November XX, 2016

Southern Nuclear Operating Company
Vogtle Electric Generating Plant Units 3 and 4
Request for License Amendment:
Classification of Nonsafety-Related Instrumentation (LAR-16-029)

Request for License Amendment: Classification of Nonsafety-Related Instrumentation
(LAR-16-029)

Figure 1: Safety Classification of Instrumentation Sensing Line, Manifold, and Instrument

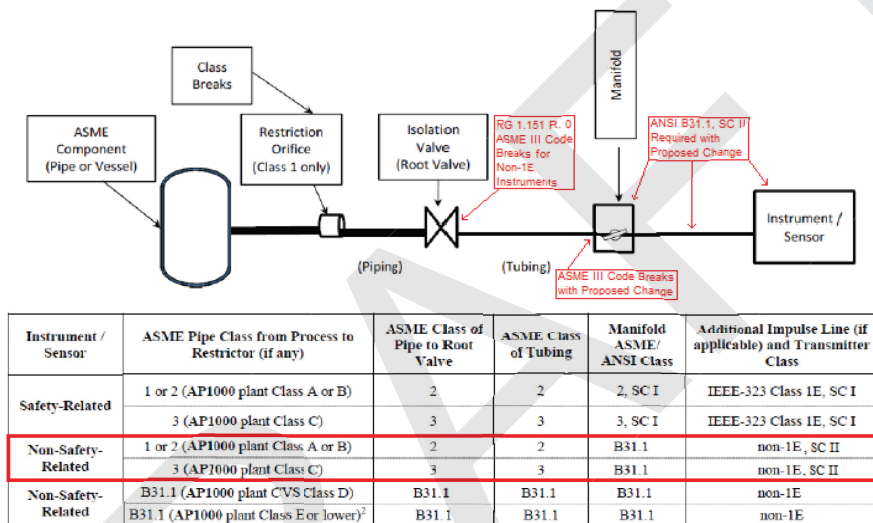
3.2.2.8 to describe that the instrument, manifold, and interconnecting tubing (additional impulse line) of nonsafety-related instruments that monitor safety-related pressure boundaries be classified as equipment Class D, seismic Category II. The instrument sensing line from the system piping to the manifold, including the instrument isolation valve, are proposed to be safety-related, seismic Category I. The equipment class applied to the safety-related portions is proposed to be the same as that of the monitored system, which is the same as for safety related instruments. The proposed changes are shown in the highlighted portion of Figure 1 below.

Note: section in red shows proposed changes, other sections are current classification methodology.

Plant-Specific Change	Description of Proposed Change
UFSAR Section 3.2.2.8	Revise to state that for nonsafety-related instruments interfacing with safety-related pressure boundaries, the instrument sensing lines and isolation valves have safety-related pressure boundary function, and the instrument manifold, sensor and interconnecting tubing are nonsafety related and seismic Category II.
